In the Planning and Environment Court
Held at: Brisbane

No. BD 916 of 2020

JUDGMENT

DEVELOPMENT CONDITIONS (AMENDED)

Figure 1: Suspended pavement encroaching within Emt J and K on RP 848032

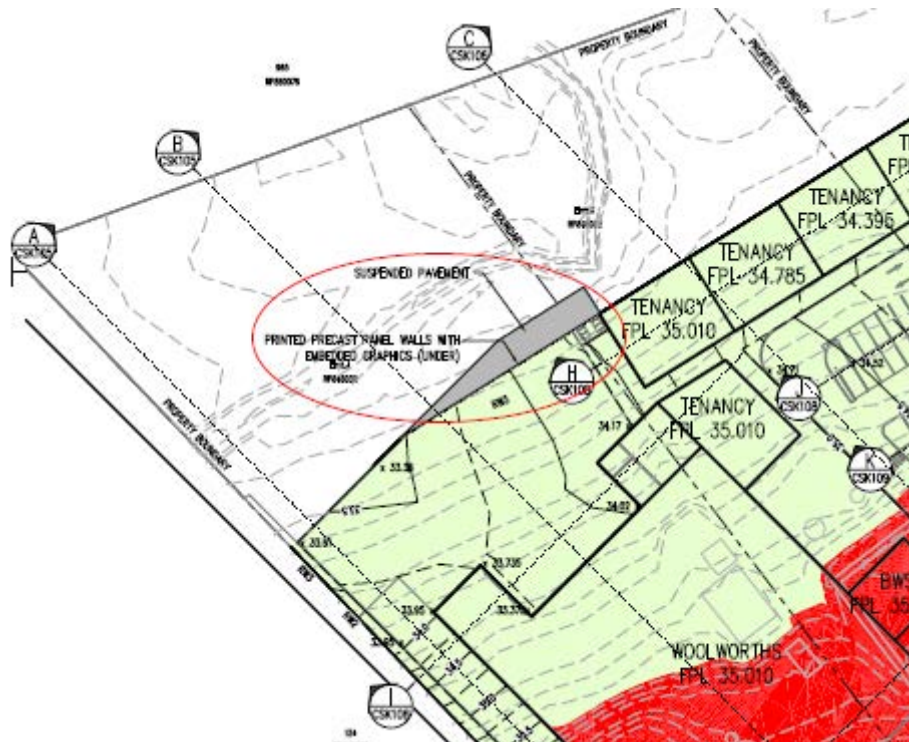
- 2.2. The development is to be wholly located outside of Easements J and K on RP 848032 with the exception of the suspended slab shown in *Figure 1*.

GROUND FLOOR PLAN

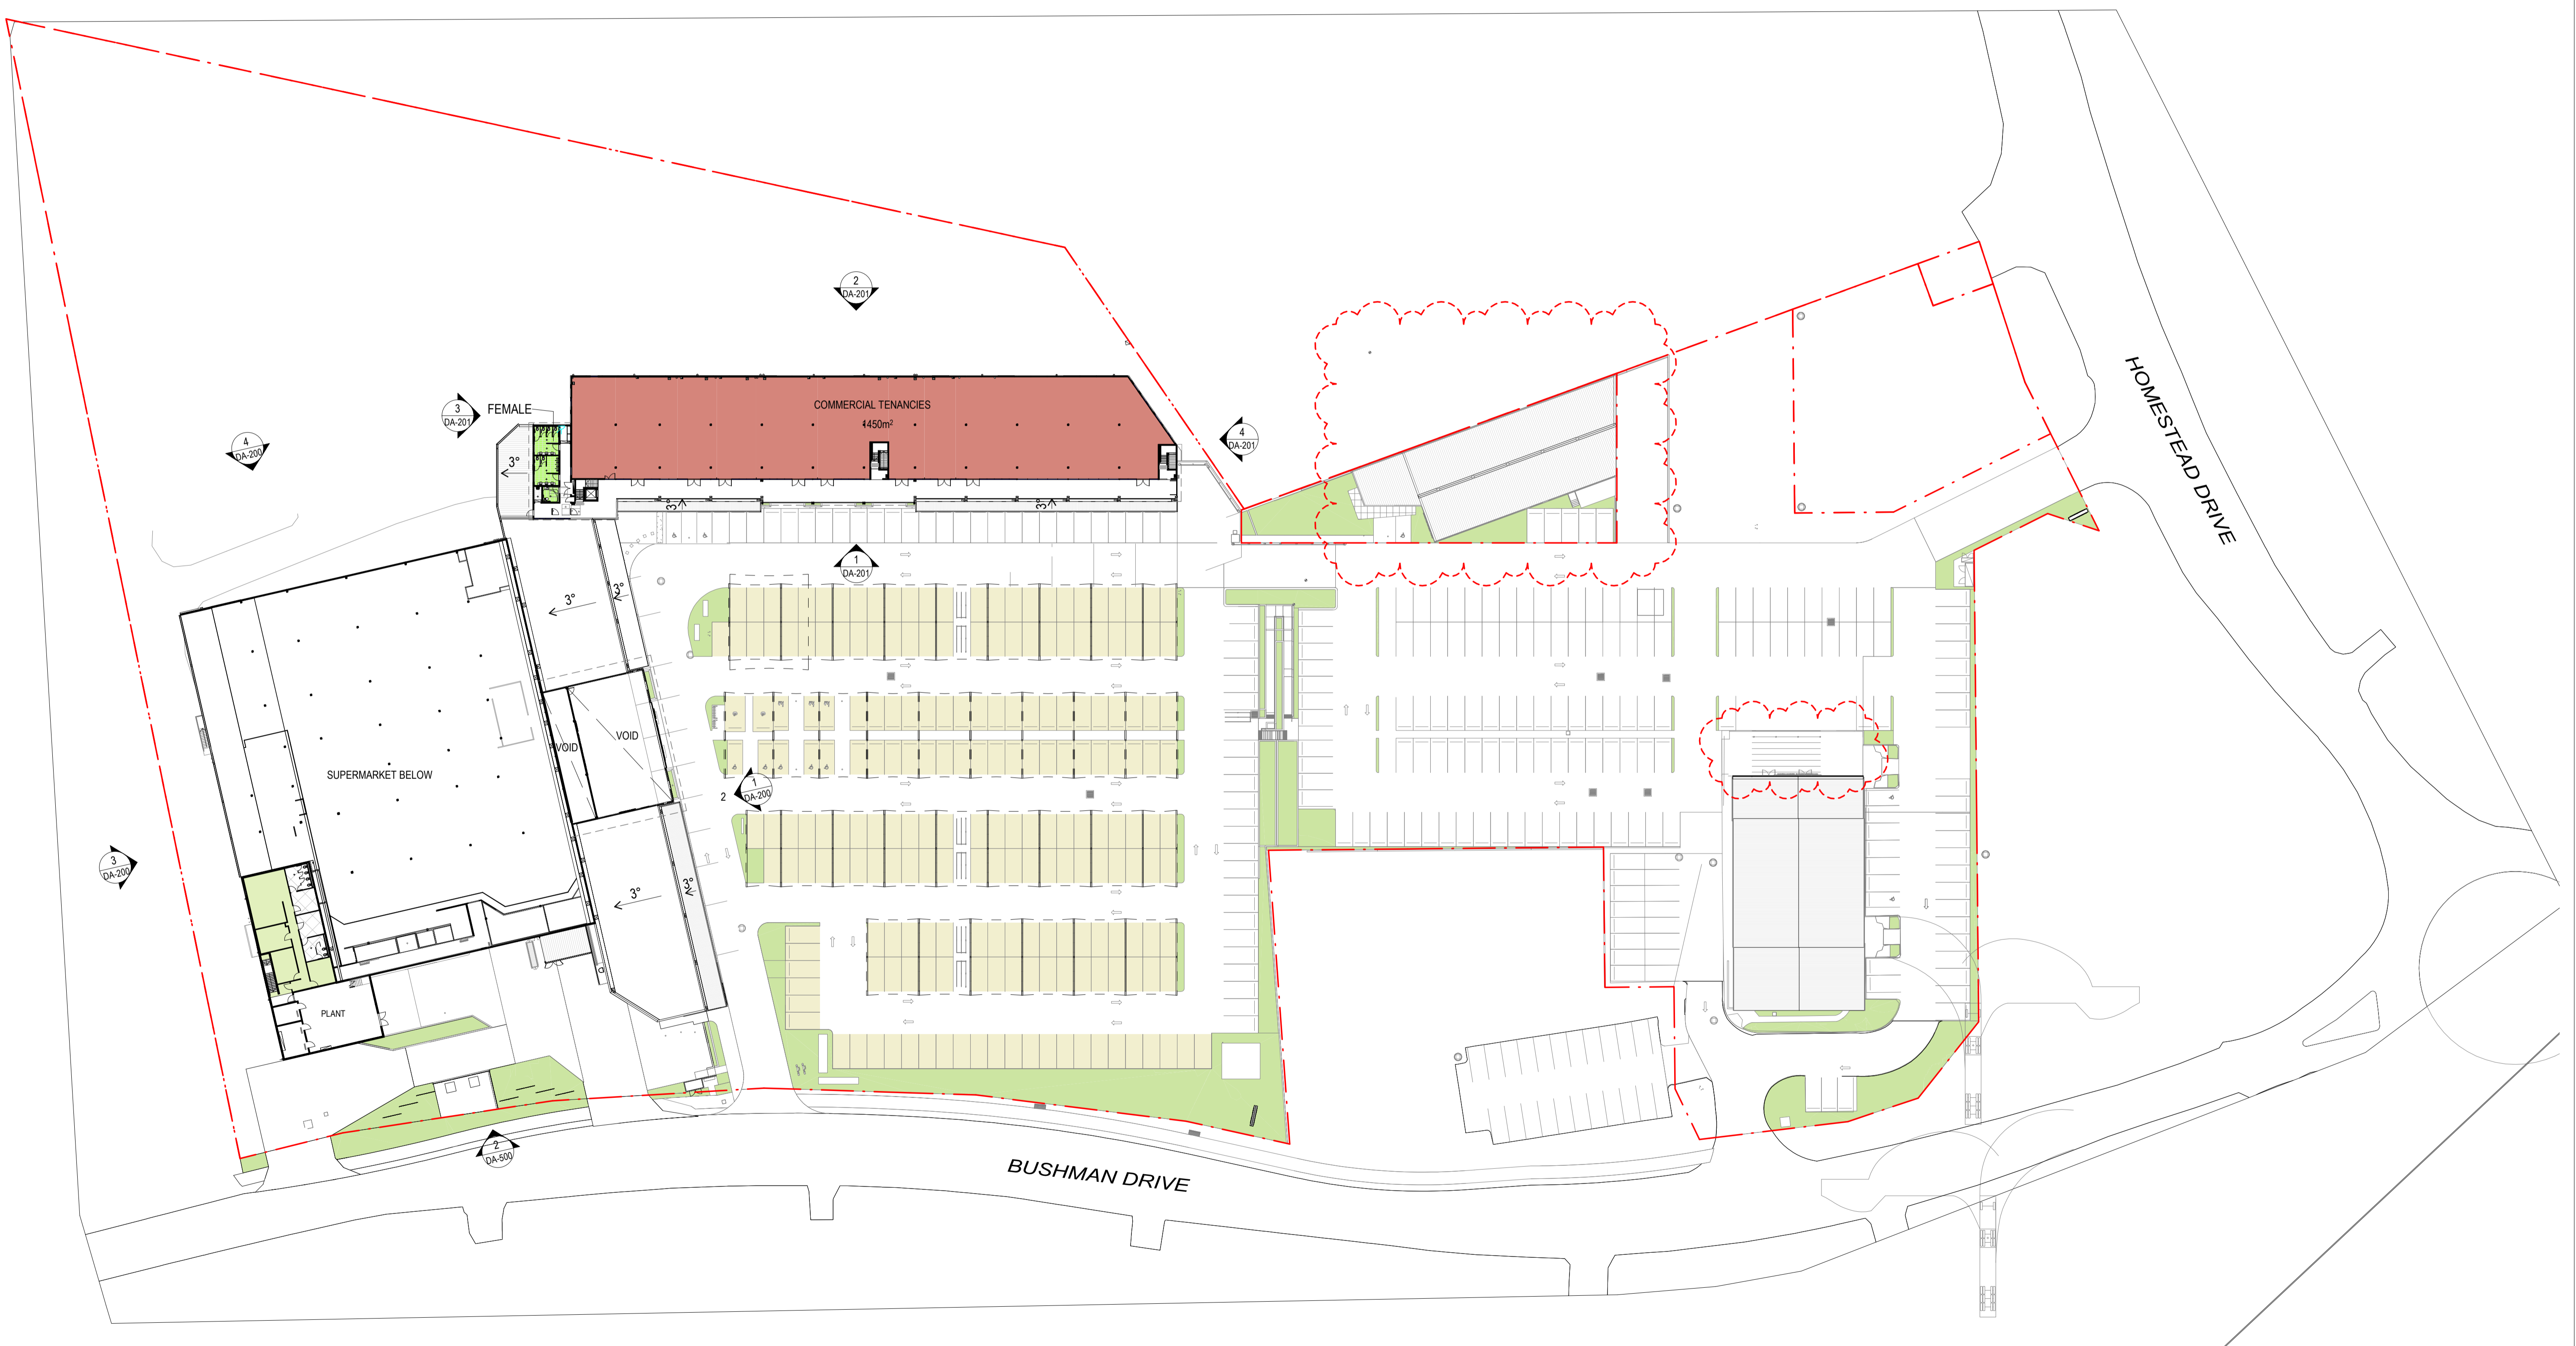
- 5.43. An operational works permit is required for parking and access.
- 5.44. Provide car parking spaces, including disabled car parking spaces, on the site in accordance with the approved plan of development, Ground Floor Plan, dated ~~08/11/2018~~ **13/02/2020**, prepared by mode.

FLAGSTONE CENTRAL - LANDSCAPE CONCEPT

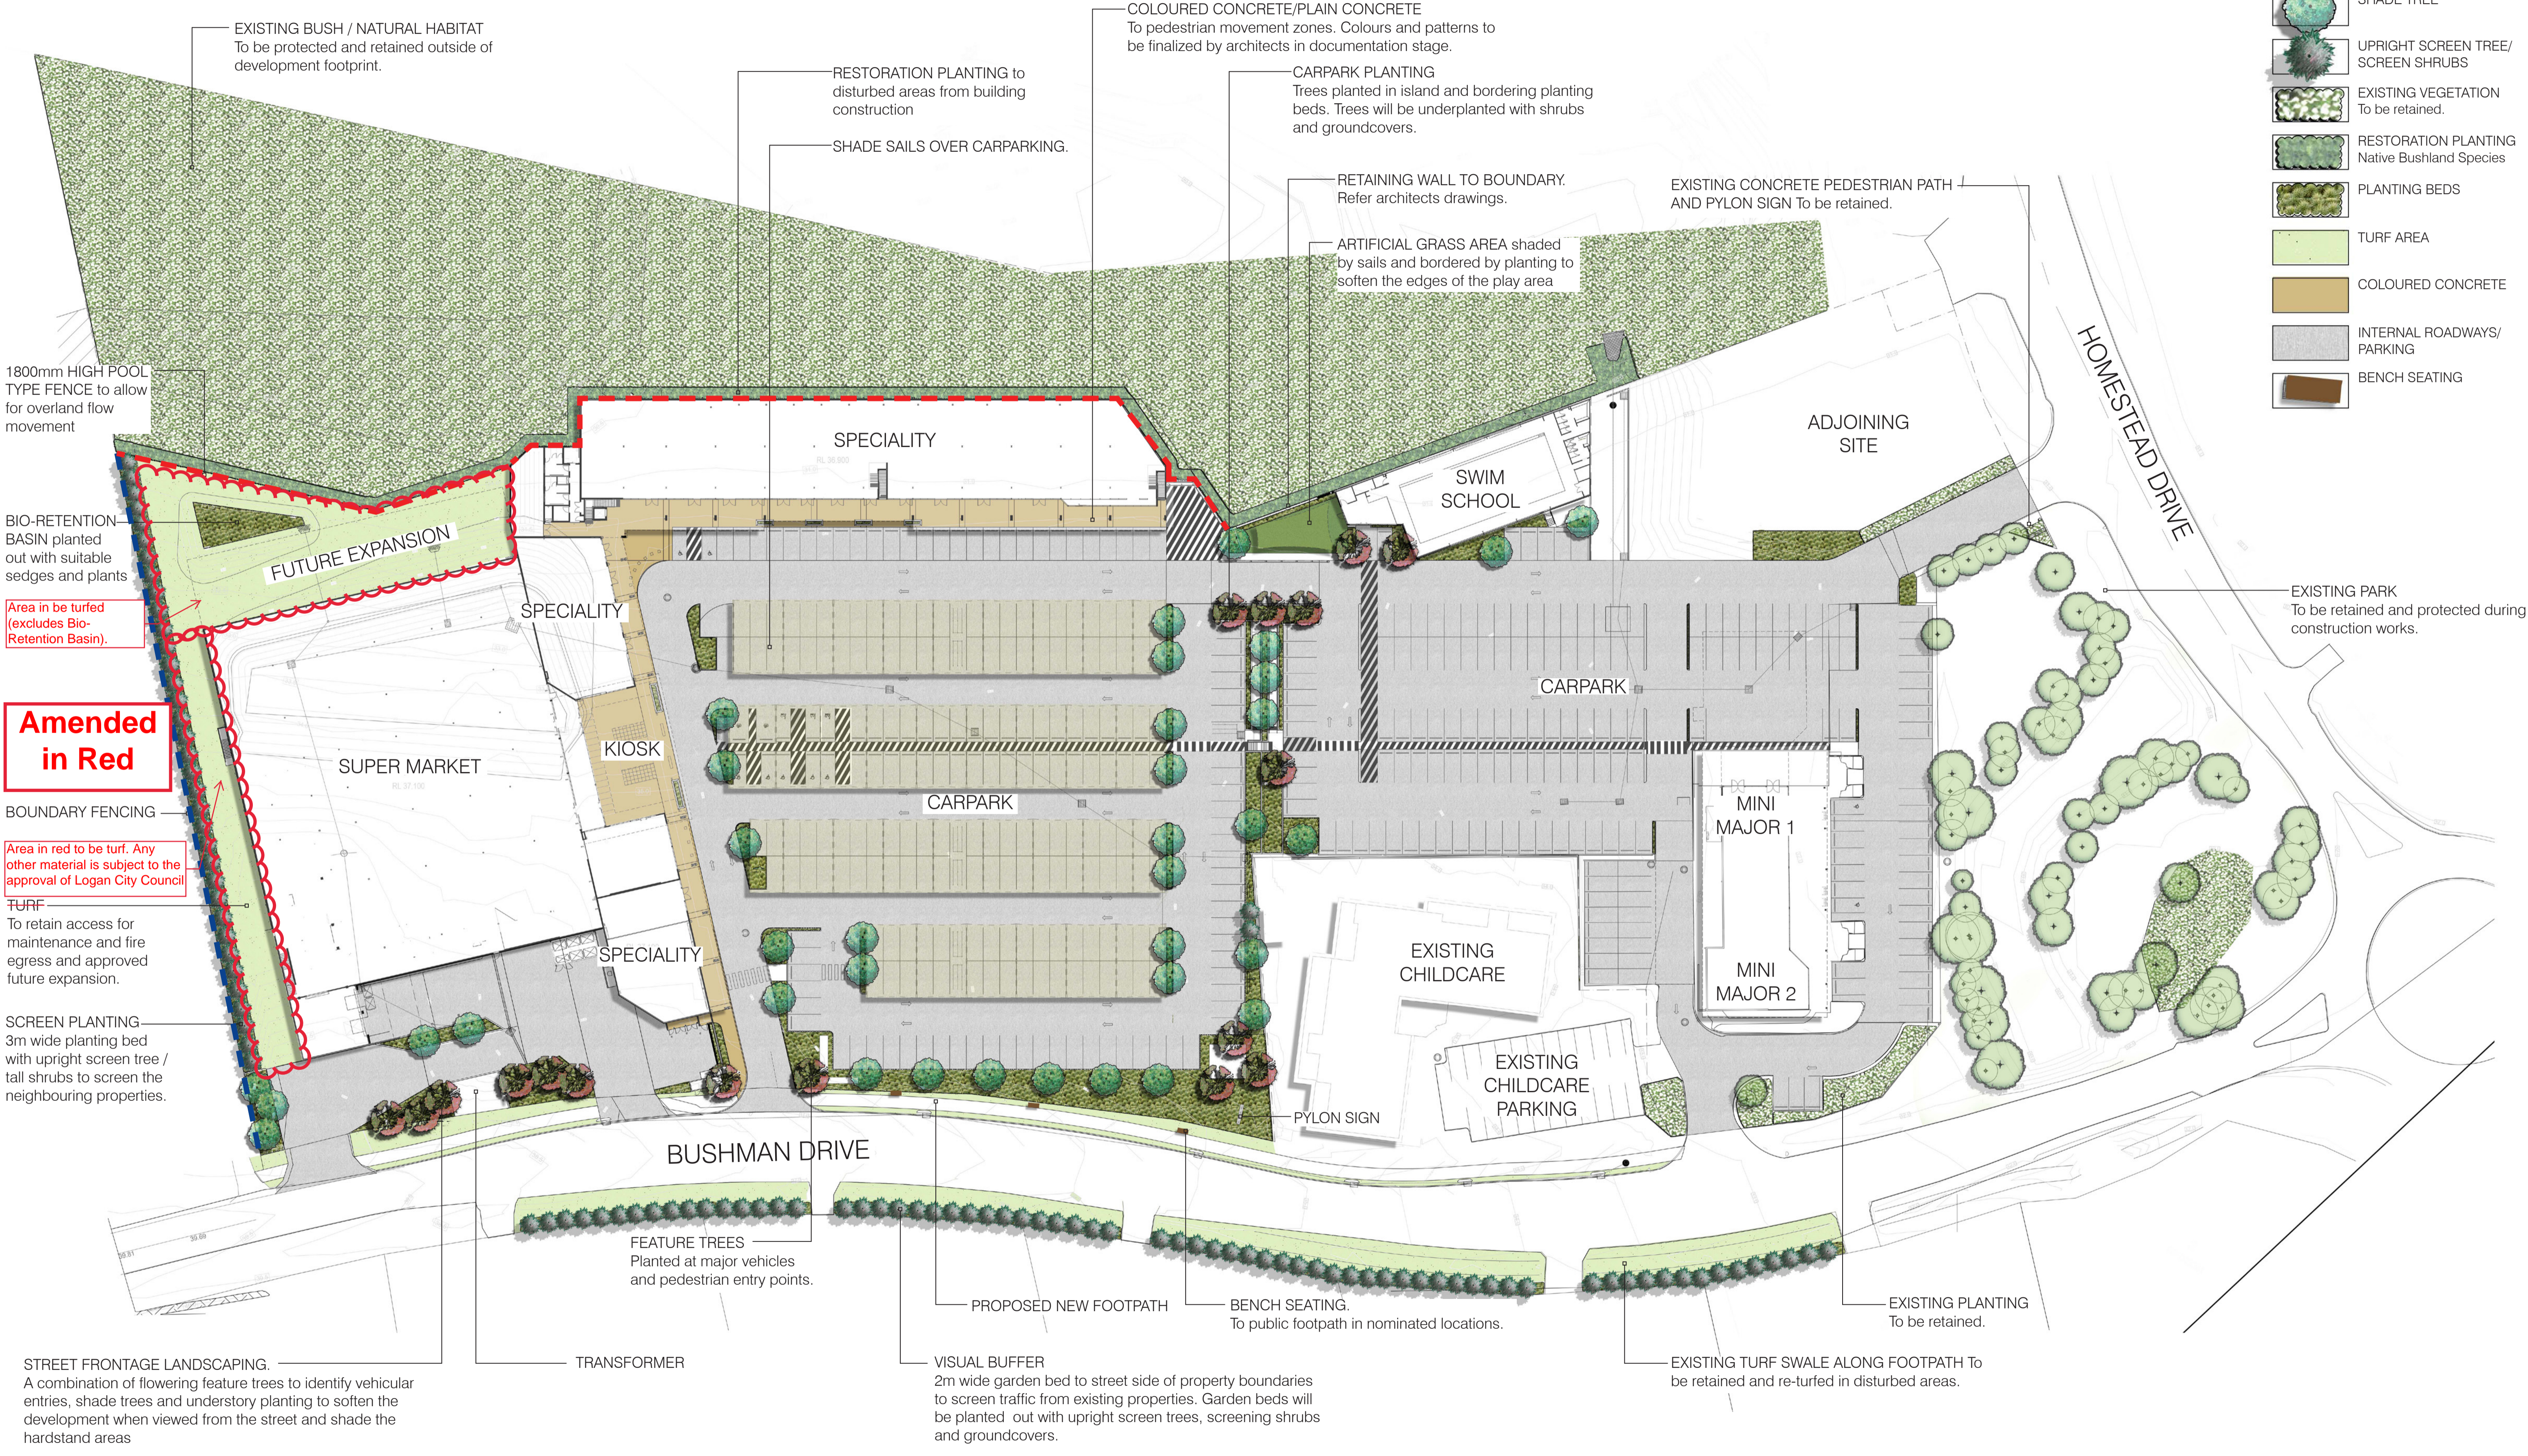
- 1.1.1. **Turf or other treatment (subject to the approval of Council) in the area shown in red on the south western boundary on the Flagstone Central - Landscape Concept, 2018.118 SK01 (Amended in Red), Revision [D] dated February 2020.**
- 1.1.2. Amend the plan view on the Screen Detail plan to include the correct swept paths from the approved Loading Bay Entry & Exit – Swept Path Analysis Design Vehicle – AV & HRV.
- 1.2. Submit to, and have approved by the Development Assessment Branch of Council, prior to any approval of Operational Works in respect to this development approval, an amended plan with the changes required in this development approval. Once approved, the amended plan will become the approved plan of development.
